PRESERVE AT MILKHOUSE CREEK SUBDIVISION

APPLICATION NUMBER 8 DATE August 20, 2020

DETAIL SITE PLAN

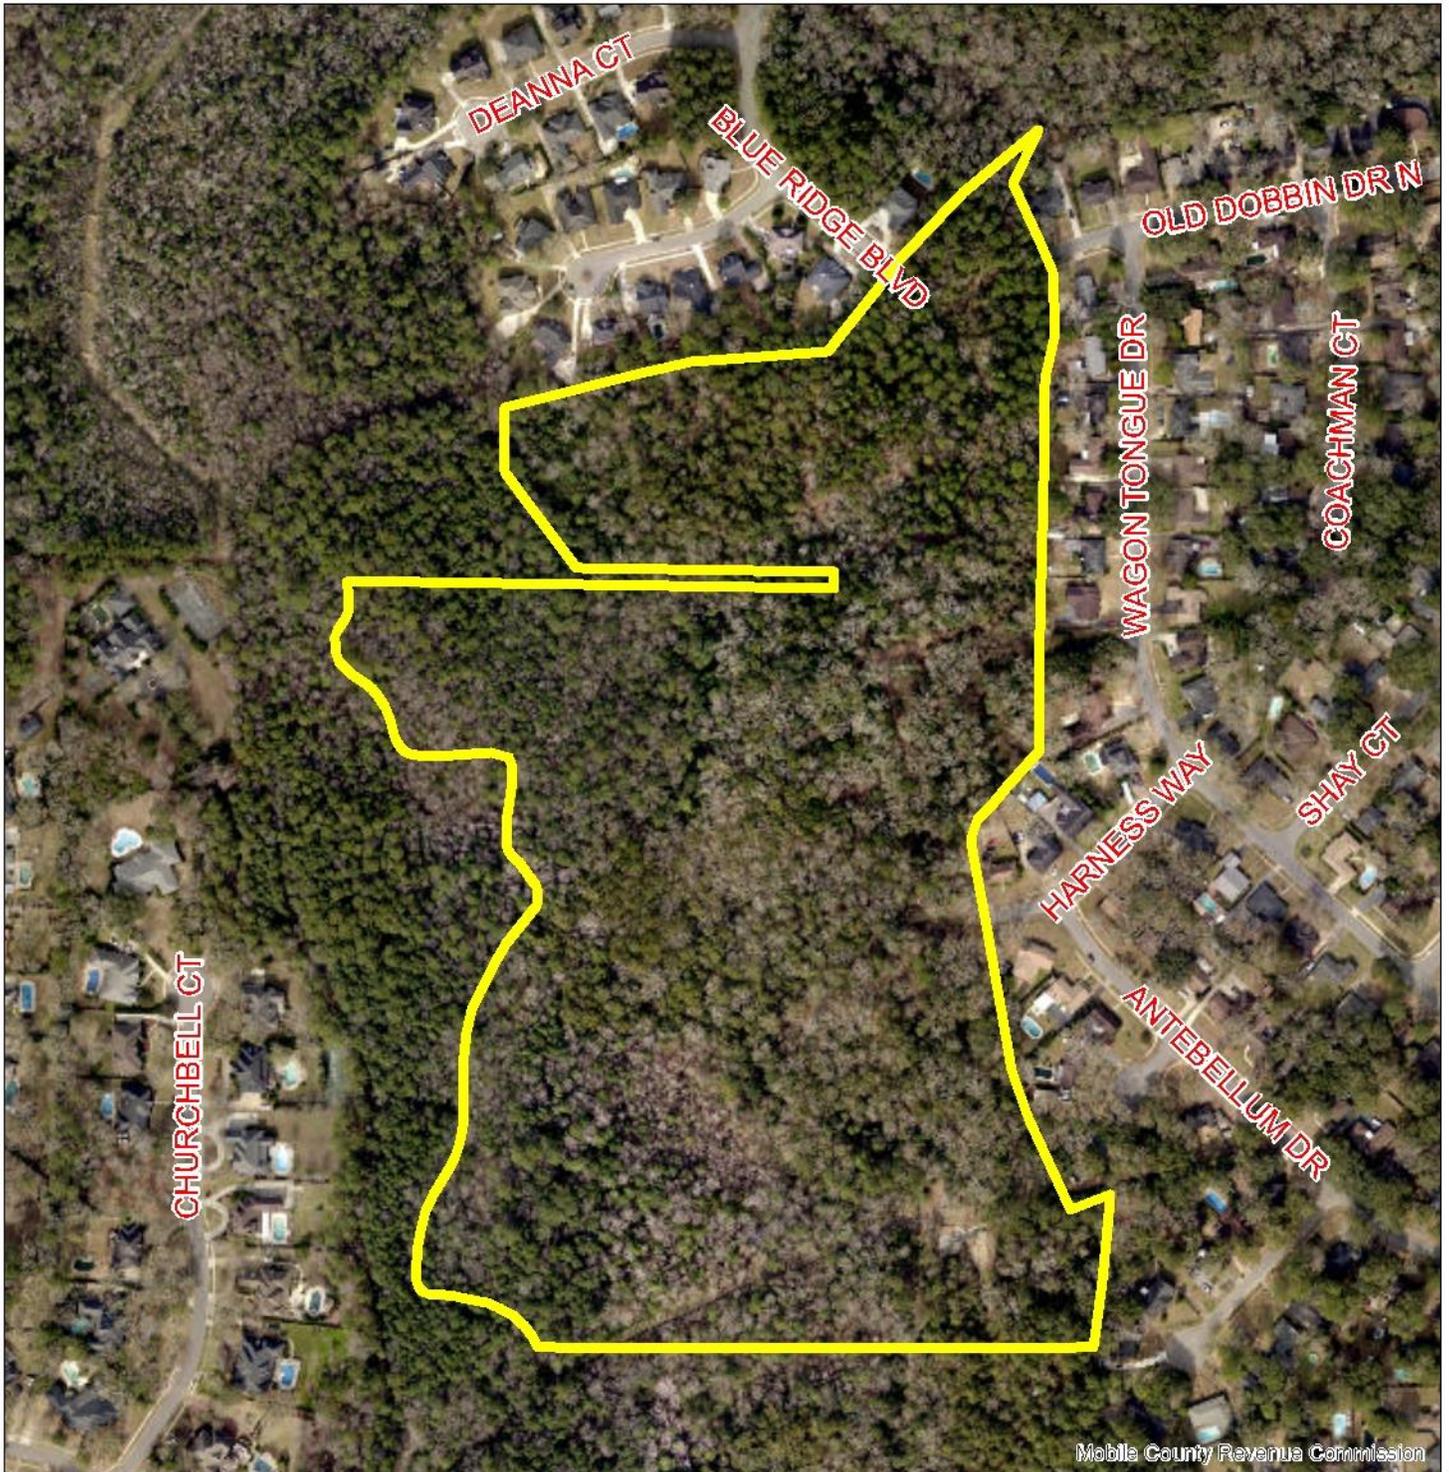
The preliminary plat indicates that access to the subdivision will be via the East terminus of Blue Ridge Boulevard, the West terminus of Old Dobbin Drive North and the West terminus of Harness Way. Proposed streets are labeled to have compliant 50' rights-of-way. The right-of-way width label for all streets should be retained on the Final Plat. Cul-de-sacs are indicated to be a compliant 120' diameter. A street stub is to be provided at the South terminus of the main interior street, Old Dobbin Drive West, for access to the future Phase 2. Corner lots are indicated to have compliant 25' corner radius curves. All lots are indicated to have a compliant and standard 25' minimum building setback from the street frontages, and this should be retained on the Final Plat.

A Site Data Table on the plat indicates that the smallest lot size would be 9,278 square feet. Therefore, all lots would meet the minimum size requirements of the Subdivision Regulations. However, none of the lots are labeled with their sizes. Therefore, the plat should be revised to label each lot with its size in both square feet and acres, or a table should be furnished on the Final Plat providing the same information.

The preliminary plat indicates that all lots will have a 15' drainage and utility easement along the front property line, a 15' drainage and utility easement along the rear property line, and a 7.5' drainage and utility easement along each side of each lot, except for corner lots. There is a note on the preliminary plat stating that no structures may be placed or constructed within any easement. This note should be revised on the Final Plat to state that no structures shall be constructed or placed within any easement without permission of the easement holder.

Approximately 28 acres of the site are to be Common Areas. There is a note on the preliminary plat stating that all proposed detention facilities, common areas and wetlands shall be the

responsibility of the property owner(s) and not the responsibility of the City of Mobile. This note should be revised on the Final Plat to simply state that the maintenance of all Common Areas is the responsibility of the property owners.

As per the Traffic Engineering comments, the driveway number, size, location and design are to be approved by Traffic Engineering and conform to AASHTO standards. A note should be required on the Final Plat stating these comments.

The plat meets the minimum requirements of the Subdivision Regulations and is recommended for Tentative Approval subject to the following conditions:

- 1) retention of the right-of-way width label for all streets on the Final Plat;
- 2) retention of the 25' minimum building setback line along all street frontages on the Final Plat;

- 3) revision of the plat to label each lot with its size in both square feet and acres, or the furnishing of a table on the Final Plat providing the same information;

- 4) revision of Note #10 concerning structures in easements to state on the Final Plat that no structures shall be constructed or placed within any easement without permission of the easement holder;

- 5) revision of Note #14 concerning the maintenance of detention facilities, common areas and wetlands to state on the Final Plat that the maintenance of all Common Areas is the responsibility of the property owners;
